Expert Opinion

Amendment C339ggee Part 2: Flood Controls to the Greater Geelong Planning Scheme

City of Greater Geelong

| Title: | Expert Opinion Amendment C339 to the Greater Geelong Planning Scheme |

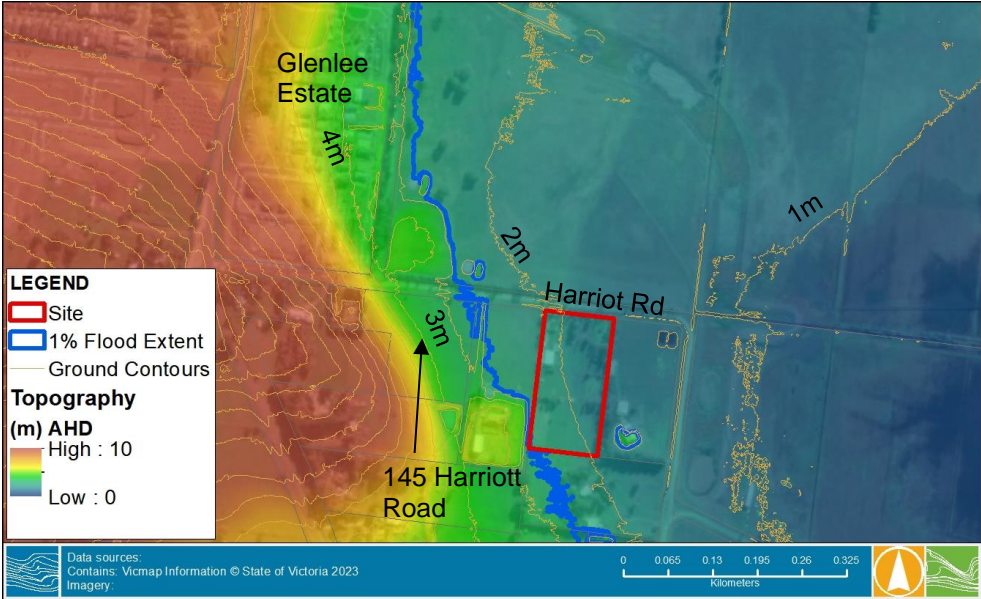
| Concerns Raised | Comments |
|--|--|
| <p>Submission 51 – 93 Bailey Street, Belmont. Floodplain on opposite side of creek is lower. Block has never had water on it.</p> | <p>The subject lot slopes substantially from the street east towards the creek. The rear of the property is approximately 1.5 m lower than the frontage. This area is on the edge of the Waurm Ponds Creek floodplain. The Figure below shows the levels at the rear of the property are similar to the low-lying land on the opposite side of the creek. The overlay is a reliable indication of potential flood extent.</p>  <p>LEGEND Site Topography (m) AHD High : 9 Low : 4 1m Contours</p> <p>Data sources: Contains: Vicmap Information © State of Victoria 2023 Imagery:</p> <p>0 0.02 0.04 0.06 0.08 0.1 kilometers</p> |

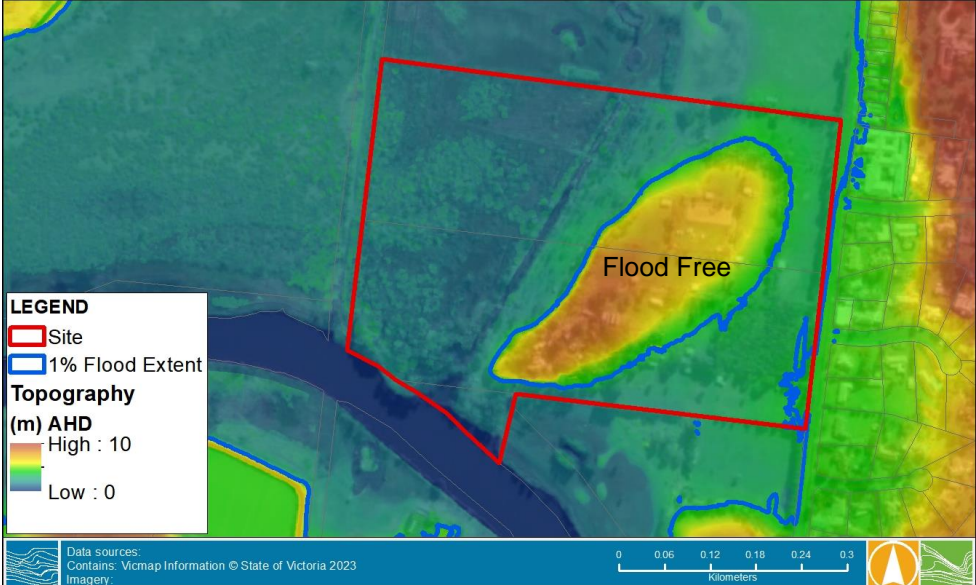
| Concerns Raised | Comments |
|---|---|
| <p>Submission 64 – 45 Lower Paper Mills Rd Fyansford.</p> <p>Property has high ground which has never been flooded (even in the 1995 flood) with a 100 year old Victorian house that has never been flooded.</p> | <p>This property is on the edge of the Moorabool floodplain. Whilst the dwelling (location indicated in the figure below) could be considered to be on the floodplain fringe, the depth criteria determine the land to be within the FO.</p> <p>The overlay will allow for any future planning application to be referred to the floodplain authority and appropriate consideration be given to the flood risk at the site.</p>  |
| <p>Submission 78 - The Heights Estate at 355 Church Street, Herne Hill.</p> <p>Subdivision of land at 355 Church Street, Herne Hill has occurred in accordance with endorsed plans which includes the area of land now proposed for a Flood Overlay. The planning permit for the subdivision of this land was supported by the Heights Development Flood Impact Assessment 2017 developed by BMT WBM. The Assessment determined that the subject land is not flood prone under development conditions.</p> | <p>The Lower Barwon and Lower Moorabool Flood Study was based on topographic survey collected in January 2017. At this time “The Heights” estate had commenced some earthworks, but filling of this area had not been completed. Hence raised ground levels resulting from the development were not incorporated into the hydraulic modelling. The 1% AEP design flood level in this area is around 8.3 m AHD. Approved plans provided to council indicate that ground levels within Salisbury Circuit and the sections shown to be flooded under the exhibited overlay have been raised to at least 9.4 m. The figure below shows the modelled and current topography.</p> <p>Lots within the Heights Estate are now higher than the applicable design flood level and would not be subject to inundation in a 1% AEP design flood. The exhibited overlay does not align with the likely flooding extent at this location. It is therefore appropriate that the mapping be clipped to the extent of filling within the Heights development.</p>  |

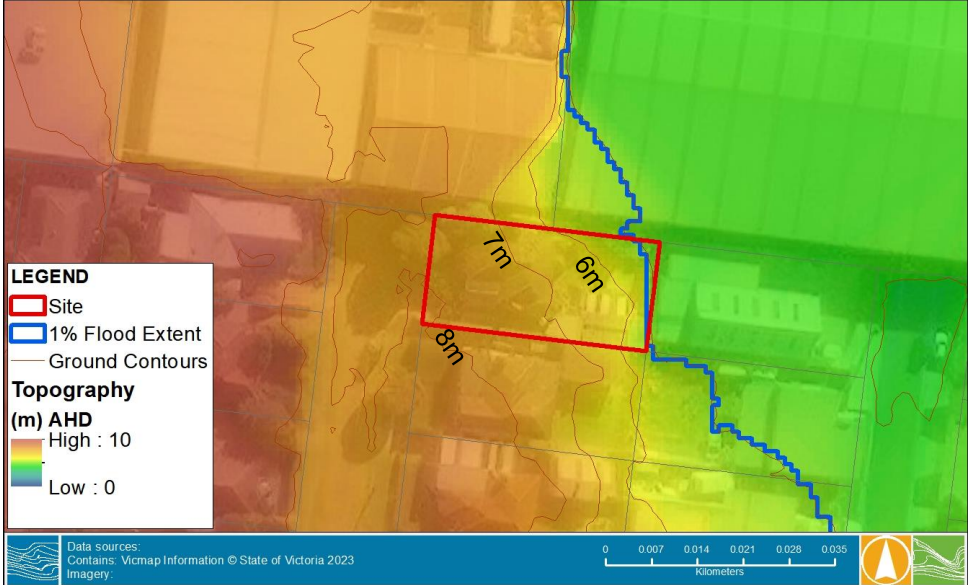
| Concerns Raised | Comments |
|---|--|
| <p>Submission 104 – 1-5 Factories Road South Geelong. Amendment needs to be clearer on the impact of the controls. Inconsistency in permitting fill in other parts of the floodplain.</p> | <p>The Schedules to the overlays essentially reinforce the principles already stated in the planning scheme and floodplain management documents (such as the State Guidelines for Development in Flood Affected Areas). They also provide a list of cases in which a permit is not required. This provides for more streamlined planning and should reduce the number of flood-related referrals to the CCMA. The most significant change is that some areas previously covered by LSI0 have been reclassified as FO. The controls related to FO are very similar to LSI0. The main difference is that sub-division is generally not permitted for areas entirely covered by FO.</p> <p>Historic patterns of fill in different floodplain areas is not directly relevant to the proposed overlays. Where historic filling has occurred, this has been included in the topography and floodplain models. Floodplain management knowledge and practices have evolved over time. Responsible authorities are obligated to apply appropriate floodplain management policies and practices into the future.</p> |
| <p>Submission 124 – 135- 143 Harriott Road Charlemont. 145 Harriott Road has almost been excluded from the LSI01 and F01 and our property is the same elevation as it? Can I have more information on why the line extends where it does, why not follow the road line? The eastern section of Glenlee Estate is the same height as the farming lots on the south side of Harriott Road.</p> | <p>Relatively small changes in ground elevation can have a significant impact on the extent and depth of flooding in a floodplain area. In flat areas, changes in ground levels are often difficult to detect by eye. Whilst the area in question may seem quite flat, the figure below demonstrated there is significant change in ground elevation along Harriott Road. The submission site is all below the 3 m contour, whereas most of the lot to the west is above the 3 m contour. The Glenlee Estate land is higher again, mostly above the 4 m contour.</p> <p>The flood overlays are guided by the flood modelling which follows the topographic contours (blue line in figure below).</p>  |

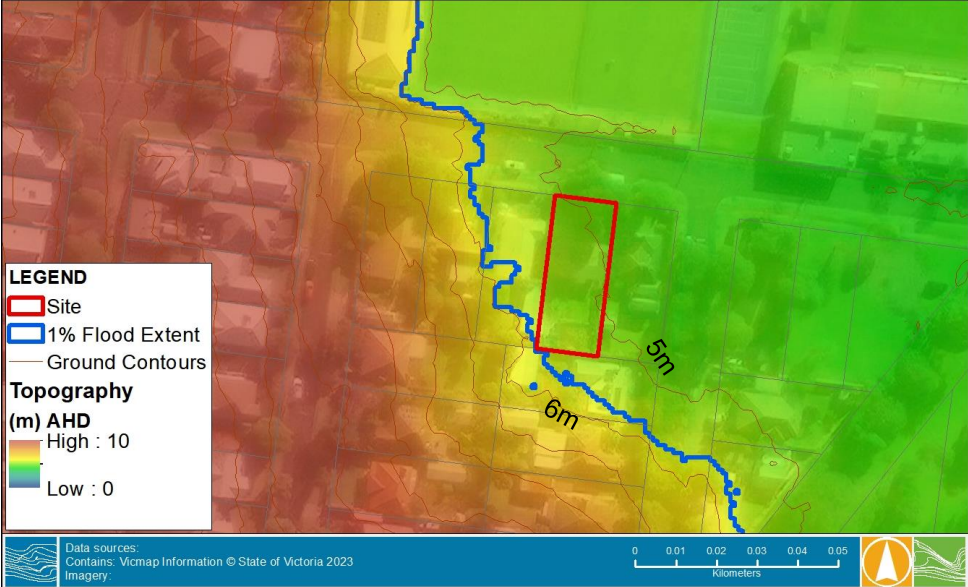
| Concerns Raised | Comments |
|---|--|
| <p>Submission 147, 372-410 Wilsons Road St Albans Park.</p> <p>Do not agree with the area identified as LSIO1 on this property. It is elevated compared to the rest of the property and above the flood level.</p> | <p>The figure below shows colour-shaded topography, with the site outlined in red. This confirms that the area within the relevant lot proposed as LSIO1 on the amendment mapping is above the floodplain. Whilst it is not common for land that is not directly impacted by flooding to be included in a flood overlay, there are instances where this can be justified. Particularly when access to a site that is not flood prone is subject to significant flood hazard.</p> <p>In this instance I consider it is important that any permit application for the site should trigger a referral to the CCMA so that appropriate conditions can be applied that related to safe flood access.</p>  <p>LEGEND</p> <ul style="list-style-type: none">Site1% Flood ExtentTopography (m) AHD<ul style="list-style-type: none">High : 10Low : 0 <p>Data sources: Contains: Vicmap Information © State of Victoria 2023 Imagery:</p> <p>0 0.06 0.12 0.18 0.24 0.3 kilometers</p> |

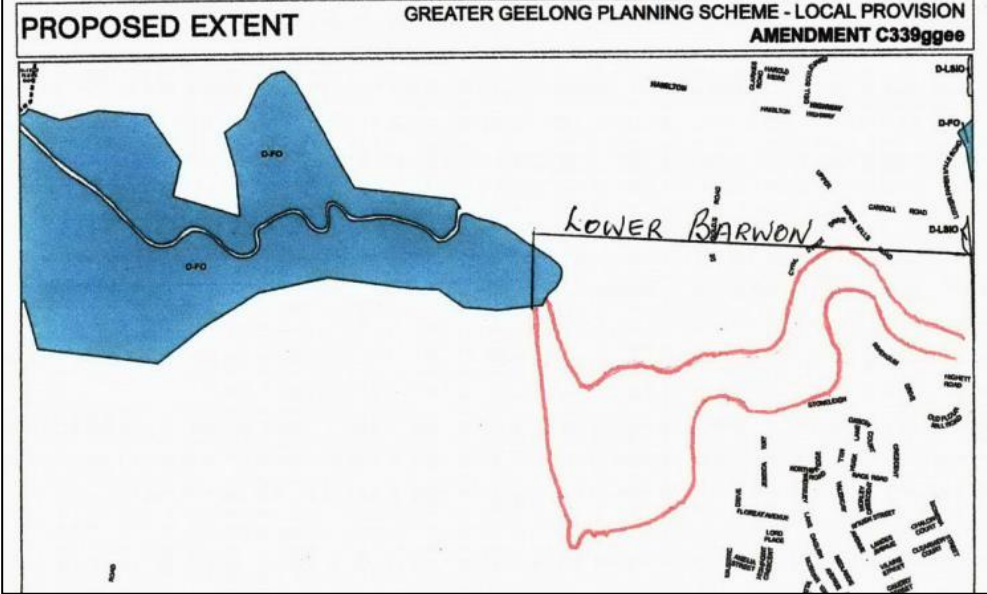
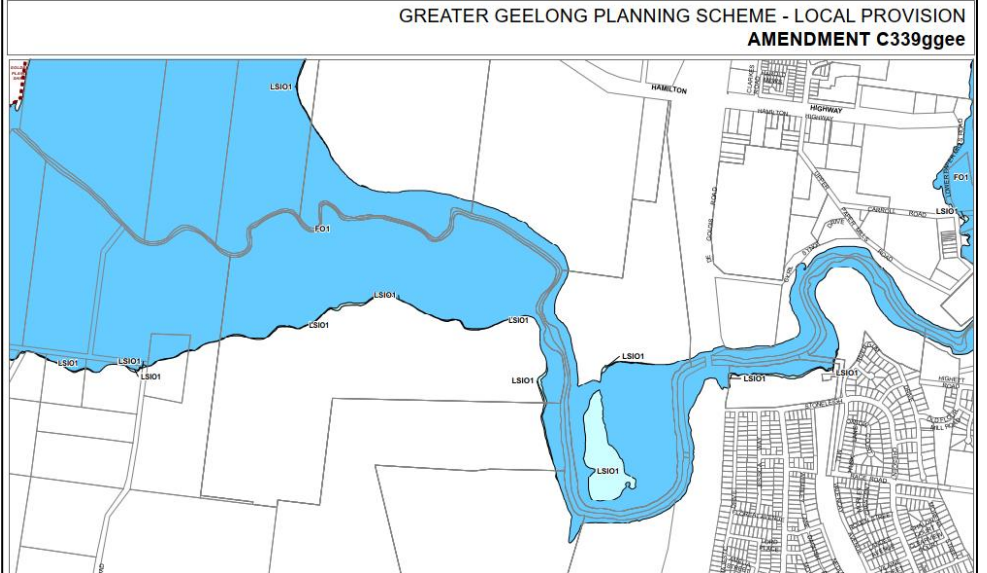
| Concerns Raised | Comments |
|---|---|
| <p>Submission 152 – 8 Merralyn Street, Belmont.</p> <p>Only a small area of lot is covered by proposed overlays in NE corner. Area is within existing easements on the land and hence can not be built over.</p> <p>Impact of other works/developments on flooding in general.</p> | <p>The figure below shows colour-shaded topography, with the site outlined in red. The topography contours are also shown with levels marked. The applicable 1% AEP flood height at this location is just under 5 m AHD. The figure below shows this site slopes relatively steeply from east to west and most of the site is between 6 m and 8 m AHD, with well over a metre of freeboard above the flood level. The area and depth of flooding in the rear of the lot is minor and is unlikely to have any impact on future development of the lot. The flood overlay(s) on this property could be removed without any detrimental impacts to flood risk management and could potentially save on unnecessary planning referrals in the future.</p>  <p>LEGEND</p> <ul style="list-style-type: none"> Site 1% Flood Extent Ground Contours <p>Topography (m) AHD</p> <ul style="list-style-type: none"> High : 10 Low : 0 <p>Data sources: Contains: Vicmap Information © State of Victoria 2023 Imagery:</p> <p>0 0.007 0.014 0.021 0.028 0.035 Kilometers</p> |

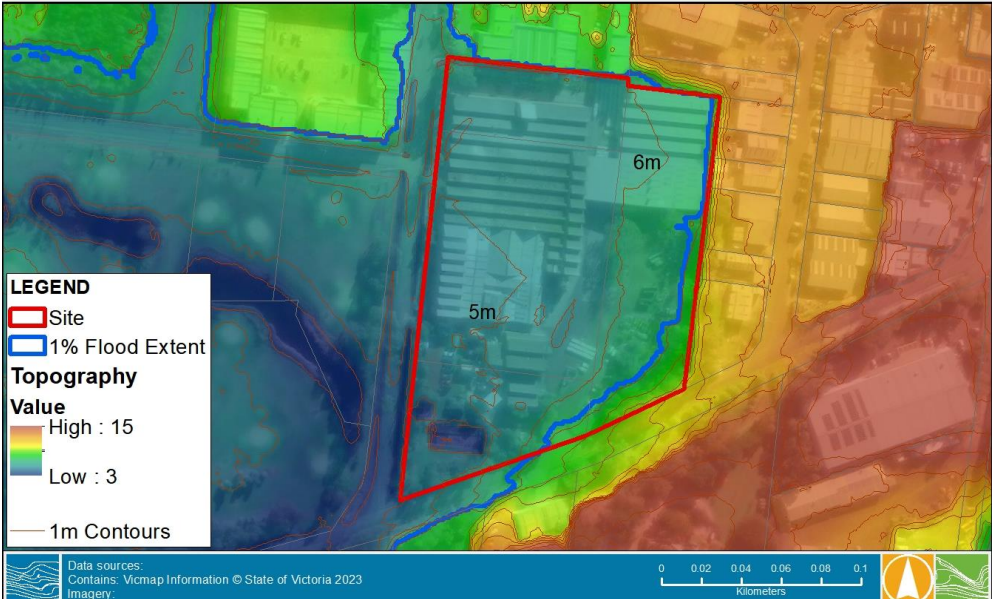
| Concerns Raised | Comments |
|--|--|
| <p>Submission 265 - 7 Sommers Street Belmont.</p> <p>Impacts of vegetation and “greening” on flood mitigation? Why has overlay changed from LSIO to FO1 when extent is the same? Is the application of “worst-case” events to determine overlays used by other planning bodies and appropriate? Overlays will increase cost of property maintenance and insurance. Propose area stays in LSIO1.</p> | <p>The figure below shows colour-shaded topography, with the site outlined in red. The topography 1 m contours are also shown with levels marked. The applicable 1% AEP flood height at this location is around 5.7 m AHD. The figure below shows this site slopes from south to north. The lowest part of the property is at the street frontage, around 4.7 m AHD which would result in maximum flood depths of up to 1 m which places this land in a high flood hazard category. The depth of potential flooding in the street for access to this property reinforces the high hazard.</p> <p>The application of the 1% AEP design flood for planning purposes is entirely consistent with planning policy and practice across Victoria and is the same as that used for other planning scheme amendments. Matters related to flood insurance have been covered in previous sections.</p>  |

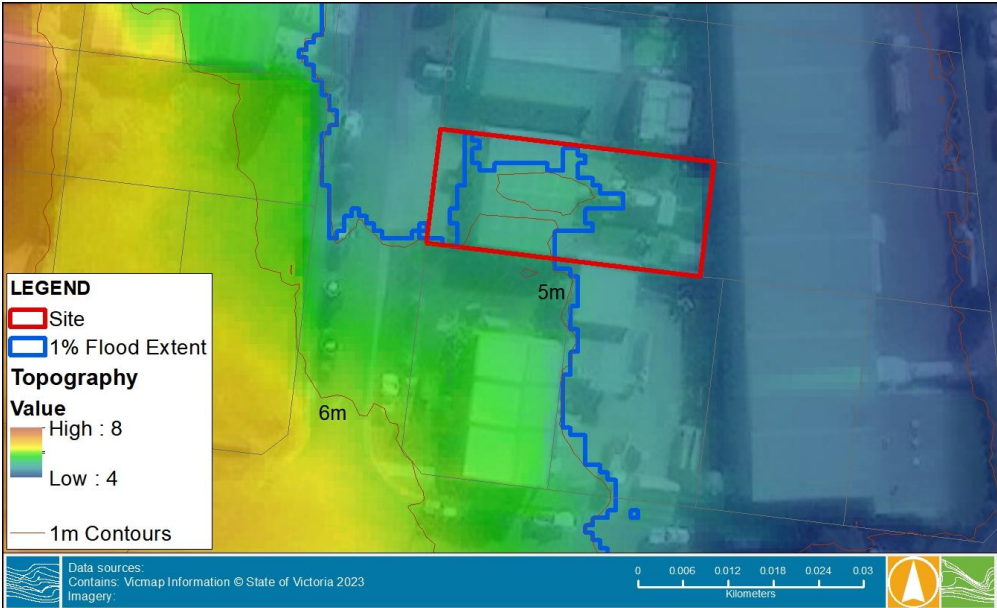
| Concerns Raised | Comments |
|--|---|
| <p>Submission 269 – 12-14 The Parade Fyansford.</p> <p>Seek clarification on the impact of surrounding development on flood levels and mapping.</p> | <p>The Lower Barwon and Lower Moorabool Flood Study was based on survey data collected in January 2017. Ground levels on the subject property are understood to range between 7.1 – 7.6 m AHD. The 1% AEP design flood level and corresponding flood extent on which the overlays are based is around 8.15 m AHD in this area. The topographic data is shown in the figure below, with the site boundary highlighted.</p> <p>At the time of the flood study the “Gen Fyansford” estate had commenced earthworks, but filling of this area had not been completed and fully developed ground levels were not included in the modelling or mapping. A detailed review of construction plans indicates that flood protection works within the estate do not extend to the subject property. The Gen Fyansford estate is filled above the applicable 1% AEP flood level to provide flood protection to all residential lots. Whilst it is acknowledged that the existing flood modelling within this section of the floodplain does not account for filling of the Gen Fyansford estate, the impact of filling is likely to be localised and only provide flood immunity to the areas shown to be filled above the applicable flood level.</p> <p>Having regard to this it is considered that the LSI01 and FO1 extent at this location be clipped to the area of fill within the development. Noting that, as the site has not been filled, the overlay should remain on that land.</p> <div data-bbox="480 835 1453 1294"> </div> <div data-bbox="480 1301 1453 1337"> <p>Data sources: City of Greater Geelong Contains: Vicmap Information © State of Victoria 2020 Imagery: Geelong Imagery 01 OCT 2019</p> </div> |

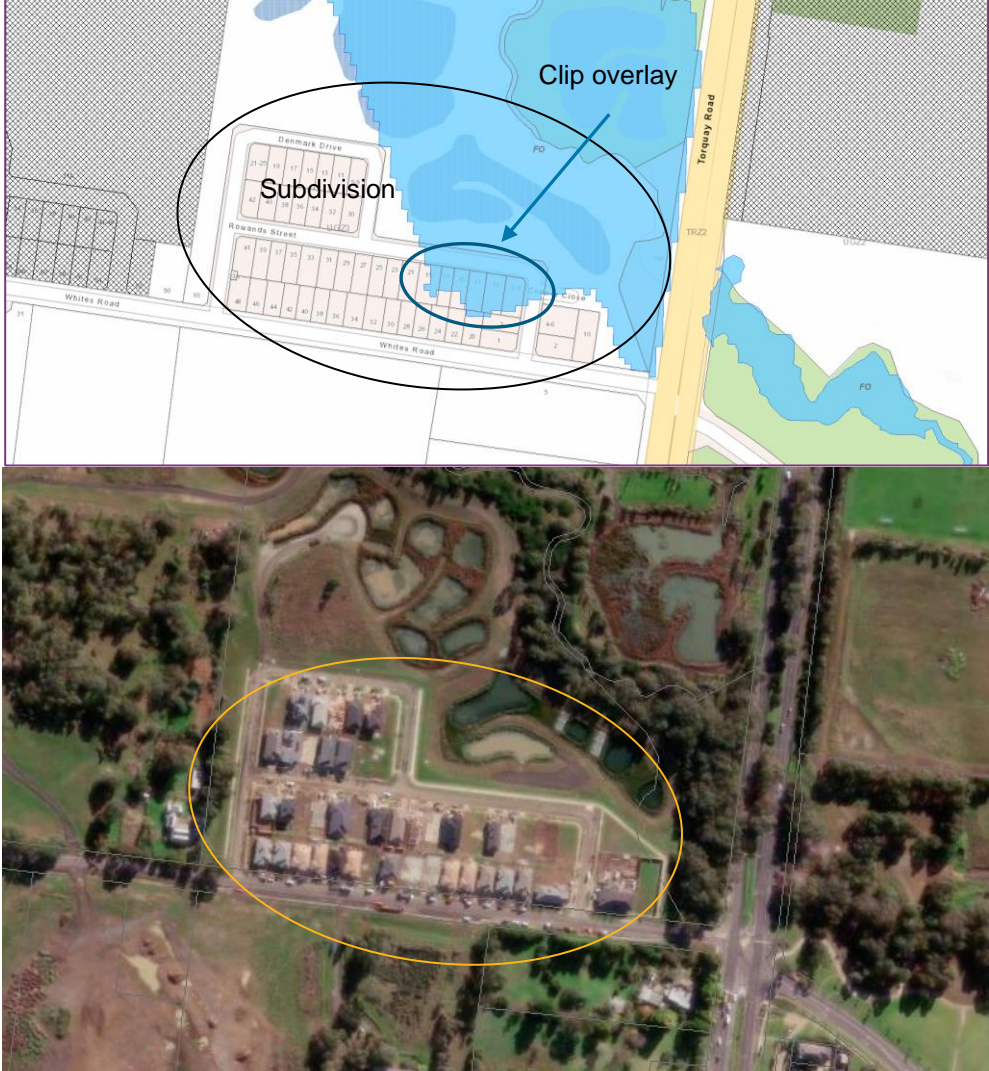
| Concerns Raised | Comments |
|--|--|
| <p>Submission 368 - 2 and 2A Tegwen Street Belmont.</p> <p>Land was filled when shed was built and is same level as the property on corner of Park and Tegwen Street (8 Park Street) and higher than Tegwen Street.</p> | <p>The figure below shows colour-shaded topography, with the site outlined in red. The topography 1 m contours are also shown with levels marked. The applicable 1% AEP flood height at this location is around 4.9 m AHD. The figure below shows this site slopes down from west to east. Approximately half the site is above 5 m AHD in elevation, and the rest is slightly below this level. Maximum depths across the site and in the street are generally less than 0.3 m which places this land in a low flood hazard category.</p> <p>The lidar survey suggests the site is slightly lower than 8 Park Street, which explains why the overlay does not extent onto that land.</p> <p>The survey levels used to develop the mapping are derived from lidar data. This is generally quite accurate and is appropriate for flood mapping purposes. There may be small differences between the lidar values and a high-accuracy local survey. If a planning application for the site is made, local detailed survey would be taken into account by the CCMA and Council in the assessment process.</p>  |

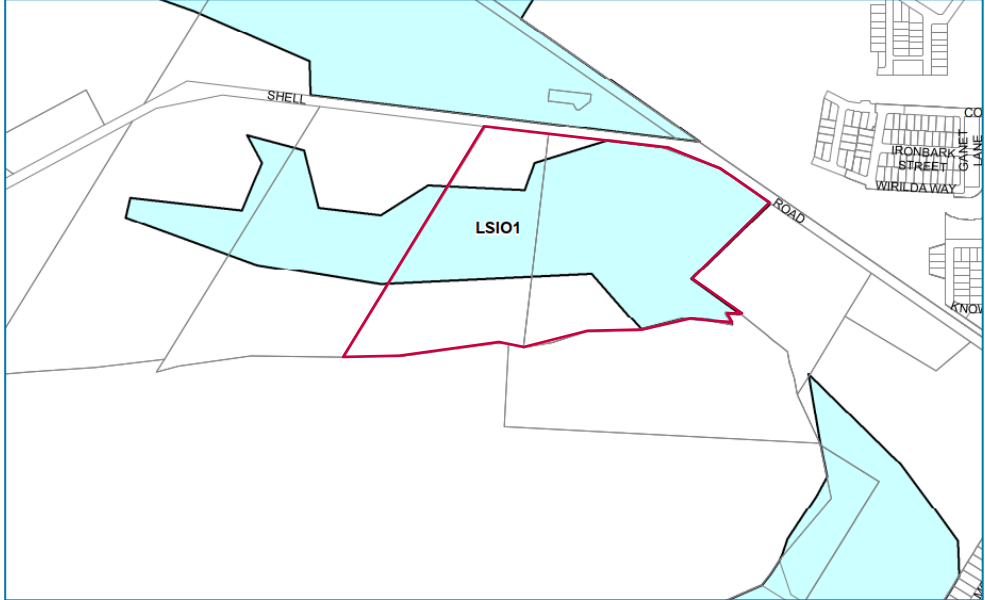
| Concerns Raised | Comments |
|---|---|
| <p>Submission 386 – 167-201 Lower Duneed Road Armstrong Creek.</p> <p>Does the flood level height on the land relate to the Barwon River or poor drainage to the river.</p> <p>Has the downstream development improved drainage?</p> | <p>The segment of overlay that covers this property is shown in the Figure below. This is the same in both the overlays to be deleted and new overlay maps. This area is not associated with any of the recent flood studies that have informed the amendment and the information source for this flood extent is unclear. I note that the site is outside the Armstrong Creek Urban Growth Area. Any future significant development of the land would likely be associated with a rezoning. Future development of the land would provide the opportunity to address and mitigate flood issues with the potential to reduce the area subject to the FO control. For the present, the proposed amendment will not result in any change the existing flooding-related planning constraints on the site.</p> <div data-bbox="491 573 1461 1211" style="border: 1px solid black; padding: 5px;"> <p style="text-align: right;">GREATER GEELONG PLANNING SCHEME - LOCAL PROVISION AMENDMENT C339ggee</p> </div> |
| <p>Submission 434 – 31-33 Salisbury Circuit, Fyansford.</p> <p>Property is not subject to flooding as it is part of a new estate designed to be protected from flooding.</p> | <p>This site is within the same area addressed in Submission 78. See response above.</p> |
